Union Sportswear Ltd. (Extension)

116, Pagar-Morkon Link Road, Pagar, Gazipur
Geographic Coordinates: 23.898500, 90.421014
17 October 2023

Executive Summary

Live load plan- 5 kPa (100 psf) for working area at 4th and 8th floor

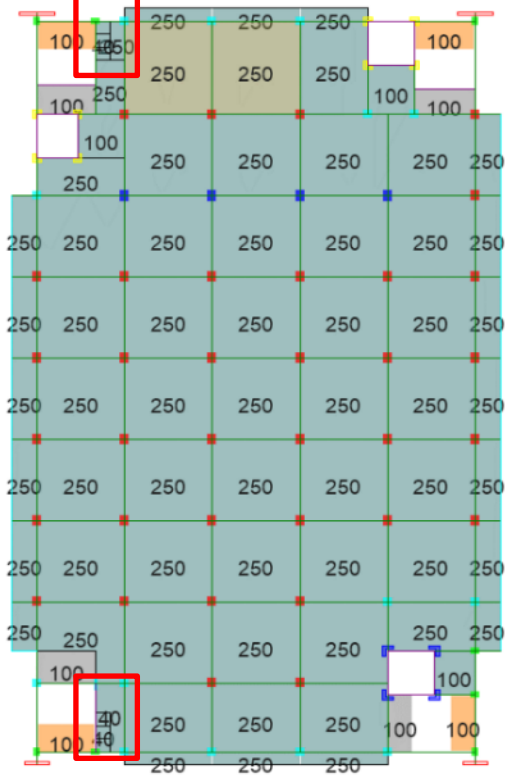
Storage live load not comply with BNBC

Live load on 4th floor and 8th floor are considered as 5 kPa in prepared load plan. As per BNBC-2020, live load for light storage areas is required to be considered minimum 6 kPa. However, the building engineer is required to revise the live load plan as per BNBC requirement and check the design accordingly.

Figure 2.8.3: Applied Live Load on 2nd floor (psf)

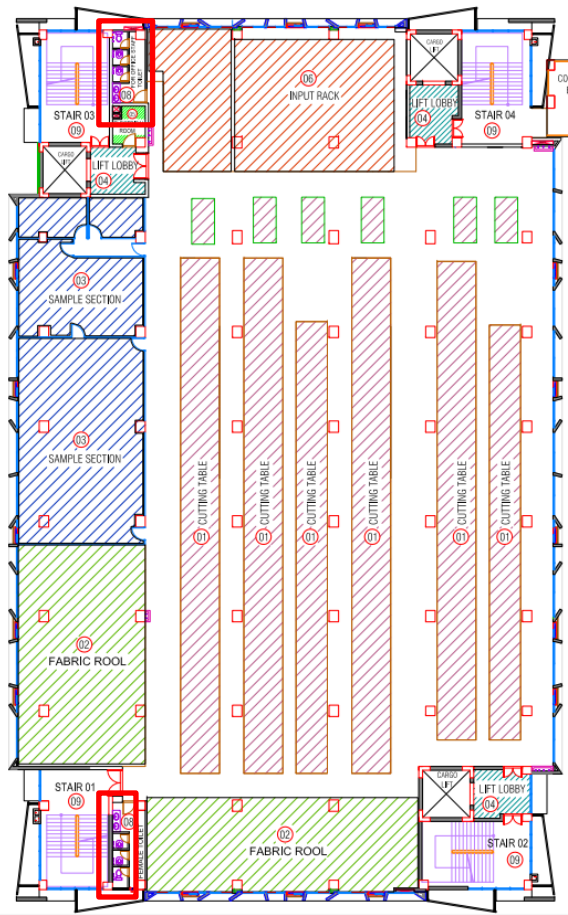
Live load: 2nd floor 2 kPa (40 psf) for toilet zone in FEA

Live load plan- 2nd floor 12.5 kPa (250 psf) for toilet zone

Live load on 2nd floor is considered as 12.5 kPa including toilet zone in prepared load plan. But in FEA, live load for toilet areas is considered 2 kPa. However, the building engineer is required to revise the load plan as per BNBC requirement and check the design accordingly.

Floor layout plan & blow up of toilet zone area.

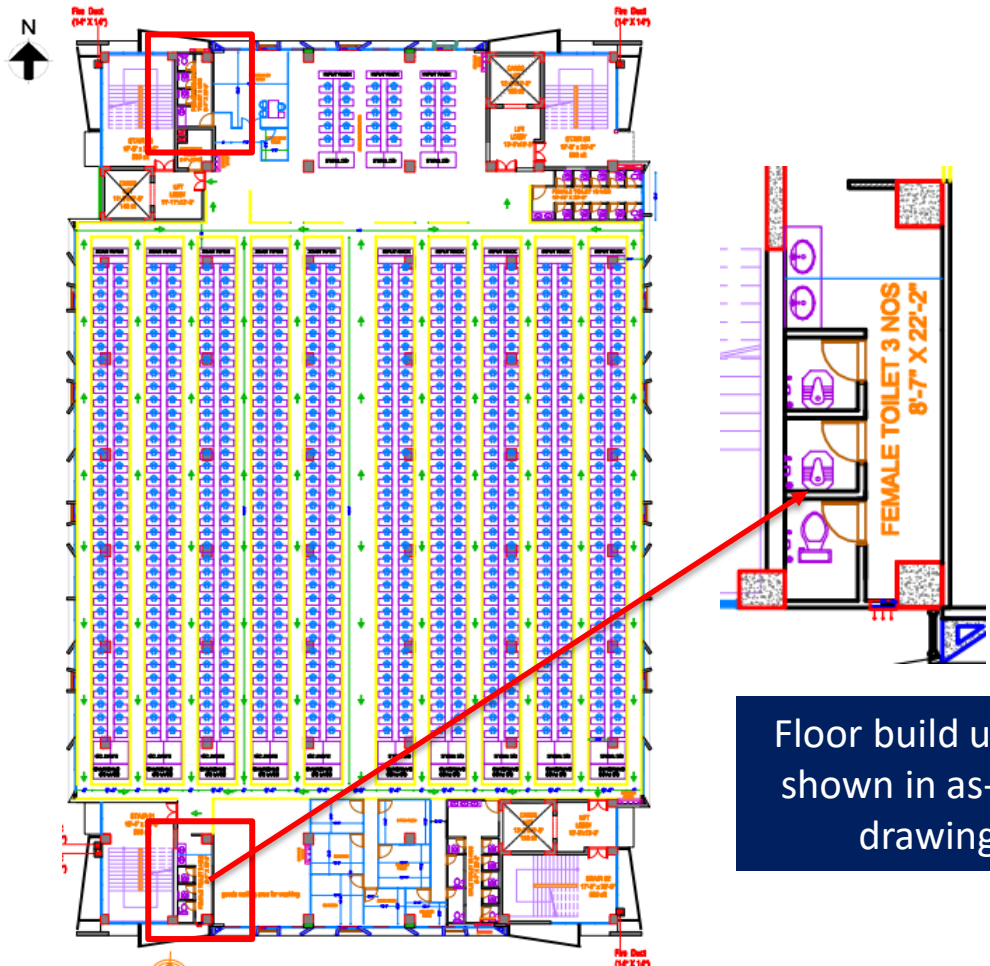
Floor build up not shown in as-built drawing

Floor build up found 450 mm

In as-built architectural drawing, floor build up were not shown. However, floor build up was found 450 mm. Building engineer is required to survey the whole structure and update the as-built drawing accordingly.

Signage of damage in wall due to trolley impact

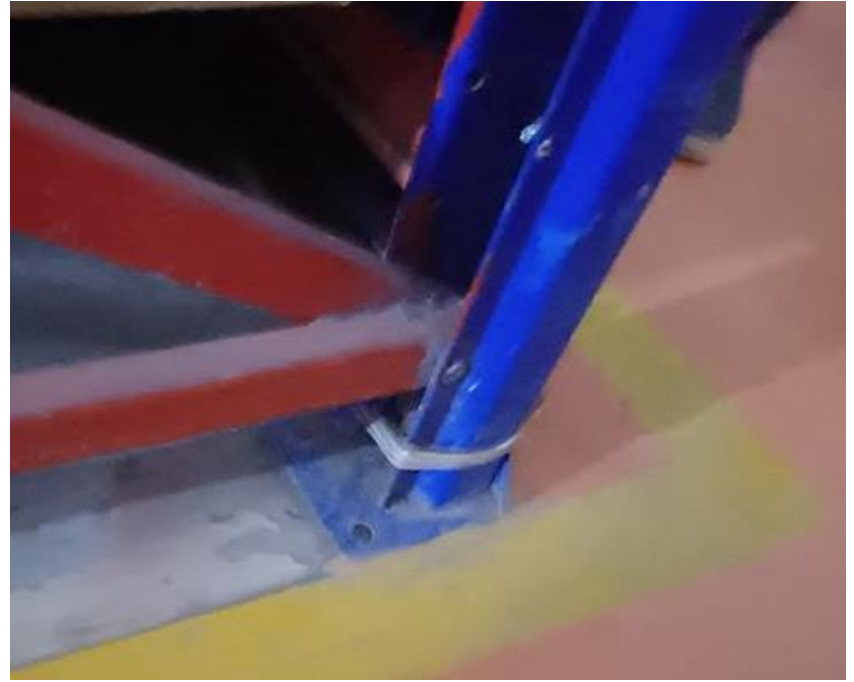
Trolley impact on column/walls

The factory is required to provide necessary column/wall guards to resist possible trolley impact.

Loading parameters in the design report

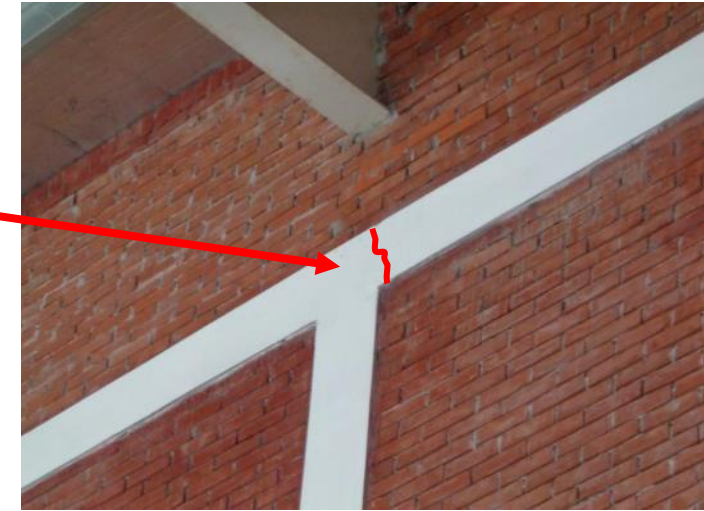
The design category of the building is SD-D which is not permitted as per BNBC-2020.

For seismic loads, only specifications & considerations are provided in design report. No detail calculations for seismic loads were available in the design report. Moreover $R=3$ is considered for steel moment frame which is 3.5 in BNBC-2020. Factory engineer is required to incorporate detail calculations for all lateral loads in the design Report in compliance with the BNBC (section 1.9.1 of part-6) and revise the design report and submit to RSC for further review.

Cracks in retaining wall

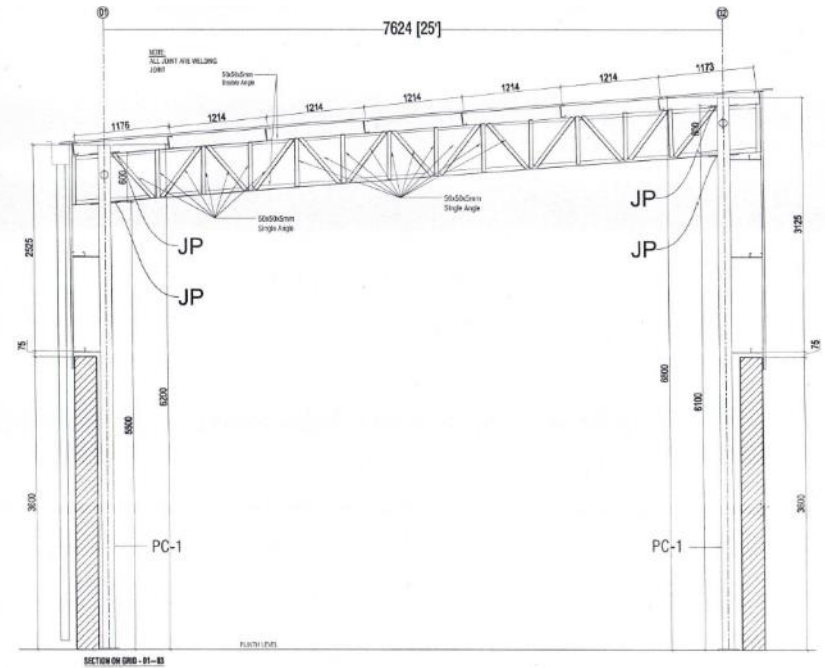
Hairline horizontal cracks on retaining wall

Horizontal wavy cracks were observed on retaining wall along the construction joint. The building engineer is required to check the structural impact of the crack and suggest proper repair methodology.
